HyNet Hydrogen Production Plant 1 – Technical Note

EPR Response 2a

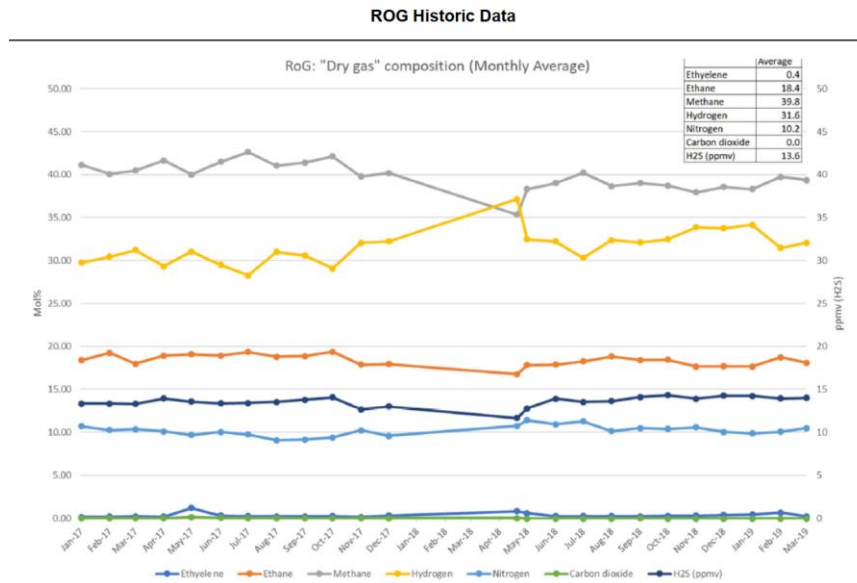
Describe any process monitoring measures and controls available upstream or at the inlet of the hydrogen production plant, to prevent feeding off-spec refinery off-gas (ROG) to the hydrogen plant, potentially leading to flaring of gas with high sulphur concentration from the proposed new flare.

As shown by the recent chart below of the compositional analysis for the ROG stream, the sulphur content is reasonably stable between 12 ppmv and 15ppmv. Therefore, the value at which the ROG stream flow is set at to prevent higher

levels of sulphur in entering the Hydrogen Production Plant (HPP1) shall be at 20ppmv (final value set at commissioning and after operational performance is completed), this set value shall close isolation valve 10-700-AAI-XZV-0003.
